Service Bulletin

Preventive checks of components which can have an impact on the driving behavior

| Title: | DX-D 100 - SB105 - Preventive Checks of components which can have an impact on the driving behavior |

Figure 6: latest design

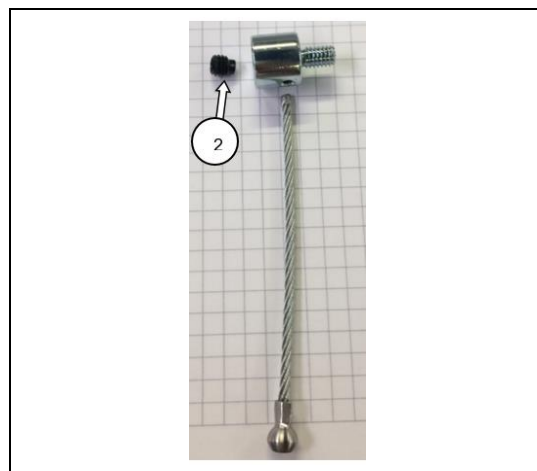
Symptom Arrestor is bended and not working.

Cause In case of a hit against the not flexible fastener (1) the arrestor could be bent.

Solution The fastener is changed by a lock screw (2) and has now flexibility in all the length of the arrestor.

If the discharger of arrestor is still the old design (not replaced during preventive maintenance yet) replace with latest design.

Figure 7: latest Arrestor Resistive Kit

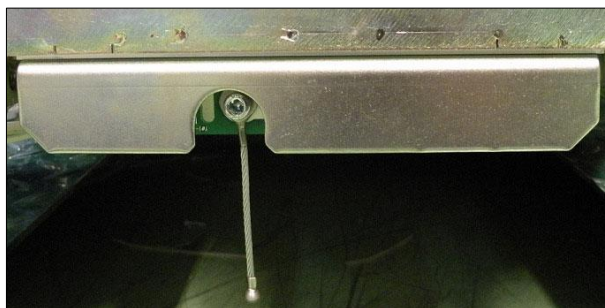
If the arrestor kit is not the new design (with metal plate + resistors+ iron wire) replace it with latest Arrestor Resistive Kit.

Figure 9: adapted design

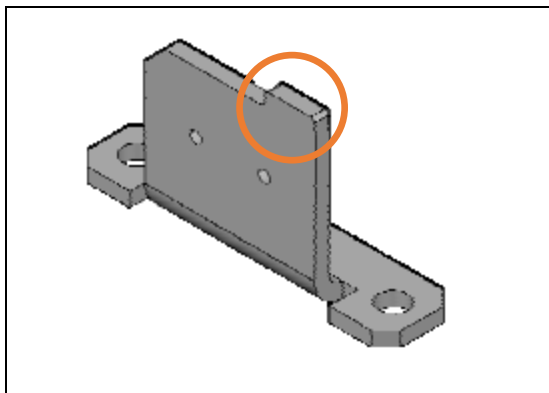
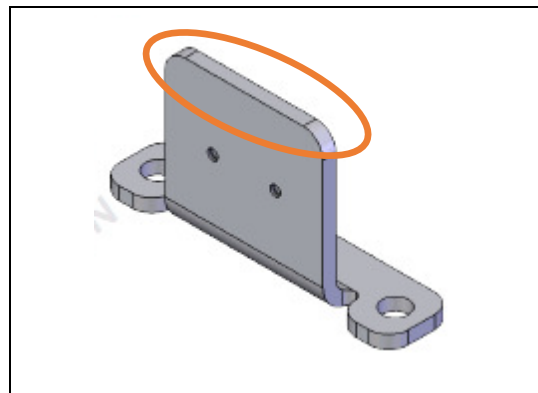
Symptom Plastic deadman bar damaged.

Cause The supports used for protection of the cam of the switches could damage the plastic deadman bar if the bar is pressed with too much force.

Solution The shape of the switches drive handle used in the handlebar assembly have been modified.
The dimension of the area which protects the switch will have been extended until the end of the support. This way the force done to the handlebar is reduced three times.

Solution In case the deadman bar is damaged, replace the deadman bar and the switches drive handle.

Figure 11: adapted front wheel material

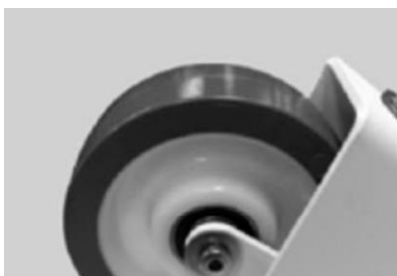
To avoid any ESD discharges and EMP (Electromagnetic pulses) the front wheels have a rolling band made of polyurethane with an ESD treatment, by adding antistatic material.

Figure 12

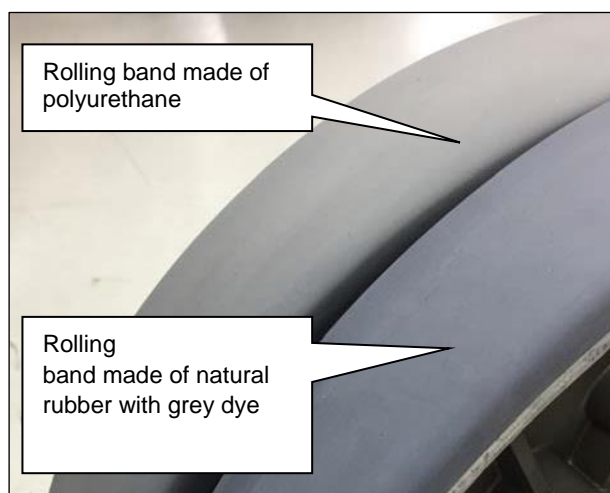
The rolling band of the optional rear wheels is made of natural rubber with grey dye.
